FIELD SERVICE BULLETIN

FSB Number: LVCCFSB2005-318
Author: Tony Bryan
Date: November 14, 2005
Total No. of Pages: 2
Subject: GSM ROKR E1 – Browser Bookmarks (Left/Right Soft-Keys)
Phone Models: GSM ROKR E1
Level of Repair: 2

Fig. 1.0 – Correct Operation

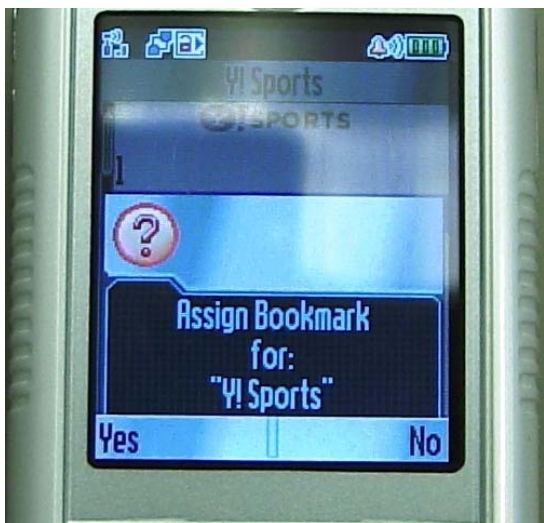
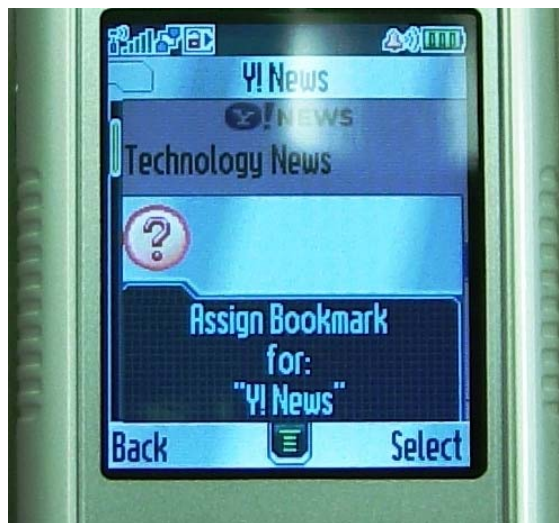
Service is aware of an issue, identified during the NPI Analysis of the GSM ROKR E1 product. Some units were returned with customer complaints of “Operation – Menu Navigation” where the complaint detail pointed to an issue while using the phone’s browser. These units were confirmed to be caused by a software issue that resulted in the incorrect labeling of the Left and Right Soft-Keys while attempting to store a Browser Bookmark. The root cause of this issue is that the browser title is not scrolling to match the browser content. The actual function of the Left and Right Soft-Keys is not affected when this issue is present but the keys are not labeled correctly. See images below.

A software solution has been integrated into software versions R373_G_0E.30.44R and later.

1. Confirm the customer complaint is related to this issue then, per the normal Service Procedure, re-flash the unit with the latest approved software for your region equal or later than R373_G_03.30.44R.
 - a. If the customer complaint is determined not to be related to this issue, then follow normal troubleshooting techniques per the customer complaint.
